July 19, 2005  
9704-PFS-107

In accordance with the Reference correspondence and 10 CFR 21, Boeing is sending the NRC the attached error notices received from our former software suppliers. Because of unknown current addresses, the following former customers were not notified:

Enclosures: GT STRUDL Program Report Forms 2005.02 – 2005.04

GTSTRUDL Program Report Form

GPRF No.: 2005.04

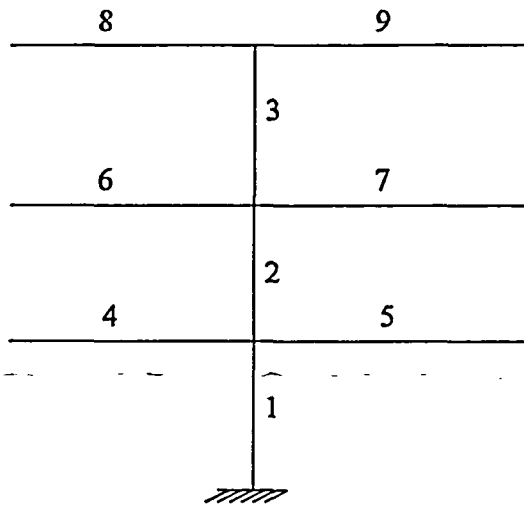
Automatic K-factor computations will be incorrect if the user specifies parameter FRLY or FRLZ for the beams or columns connected to the member for which the K-factor is being computed.

**Example:**

COLUMN LINE 'COL1' MEMBERS 1 TO 3

FRLY	0.5	MEMBERS 4 TO 9
COMPK	KZ	MEMBERS 1 TO 3

Specify the parameters LY and LZ for the unbraced length. Do not use FRLY and FRLZ when requesting the automatic K-factor computation.

The problem with parameters FRLY and FRLZ only affects the automatic K-factor computation. Parameters FRLY and FRLZ are correctly implemented for all other steel design code check or select commands.
